REPORT
ON
REQUIREMENTS FOR DEVELOPMENT OF
A REHABILITATION PLAN
CLINTON CREEK MINE
CASSIAR ASBESTOS CORPORATION
(1977)

Prepared for:
Yukon Territory Water Board

Prepared by:
R.M. Hardy & Associates Ltd.
Calgary, Alberta

December 30, 1977

- #1 Failed portion of tailings embankment. Failure occurred in 1974. Cracks throughout the failed mass indicate current movement.

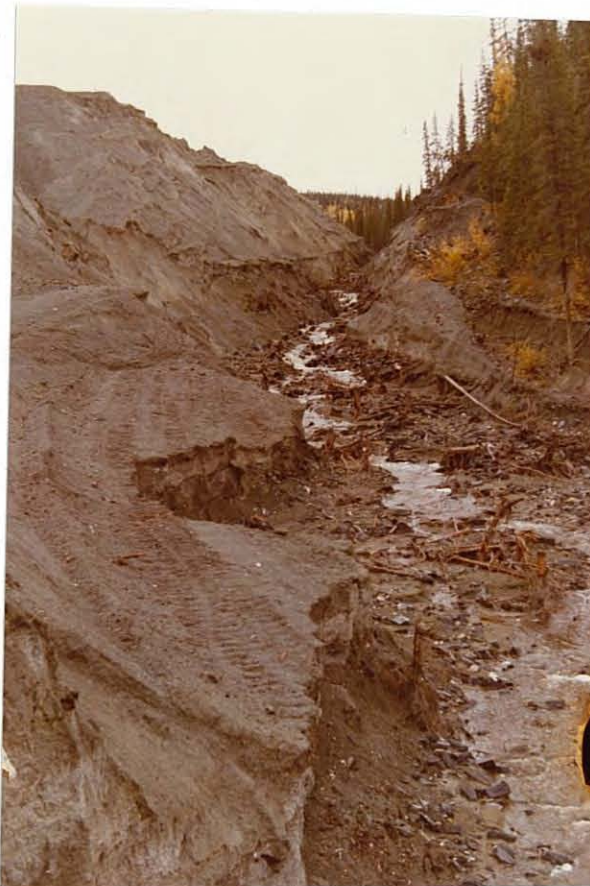
Photograph 1 shows the failed portion of the tailings pile. The failure occurred in 1974. It is clear from the cracks on the pile that movement is still occurring in this area. There also seems to be a substantial amount of spreading at the bottom. We are unable to assess to what extent the spreading was carried out with mechanical equipment at the time that the channel was bulldozed through. Photograph 2 shows a view of the channel that was evidently bulldozed in 1974. The very fresh face of the right bank indicates it is moving and experiencing continual erosion. It is obvious the channel has squeezed shut to a large degree since it was bulldozed open. Photograph 1 also shows a lobate form north of the failed area which was reported to have been moving at a rate of 3 inches (76 mm) per day in January 1976. Observations of movement had been taken only over a relatively short period.

This photograph, as well as the aerial photograph,

indicates that the direction of movement of the southern portion of this slope is towards the mass that failed in 1974. A substantial amount of bulging at the bottom indicates the failed mass is supporting the south side of this slope. In our opinion it is quite possible that a failure similar to that experienced in 1974 could occur at this location. The movement appears to be a combination of flow within the tailings mass as well as a failure of the foundation soils.

#8 Eroding bank of natural slope immediately downstream from culverts.

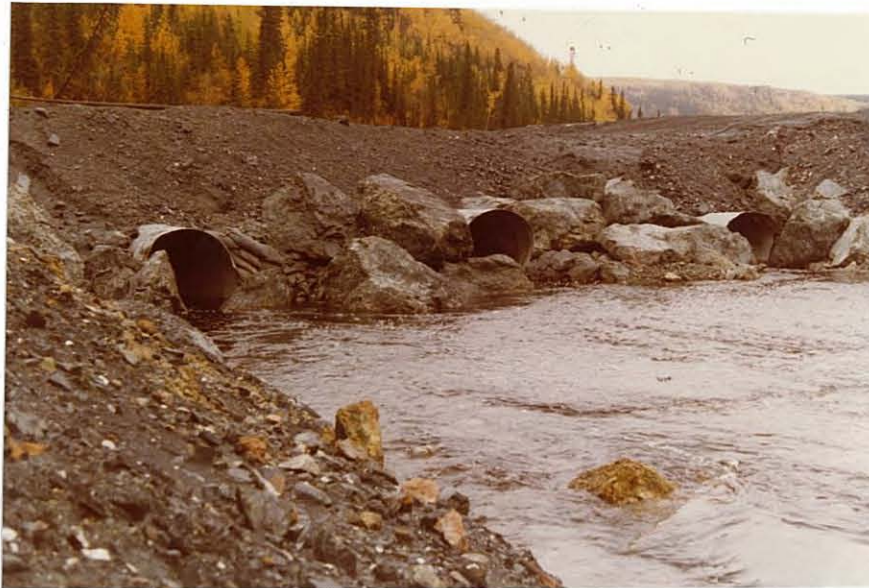
Bottom heave has also been reported from the previous observations at the site. Photograph 8 shows the left banks of natural soil downstream from the culverts. We understand that the maximum flow for 1977 occurred in May and was equal to approximately 1000 cfs ($28 \text{ m}^3/\text{sec}$). A large amount of fines was eroded from the toe of the slope as shown in photographs 9 and 10, leaving a

boulder paved bank. Accurate records of peak flow are not available but we understand that they will be obtained in the future beginning in 1978. It is clear that extensive erosion can be experienced during peak flow periods depending upon the duration. Further erosion will initiate accelerated movement of the slopes of both the left and right banks.
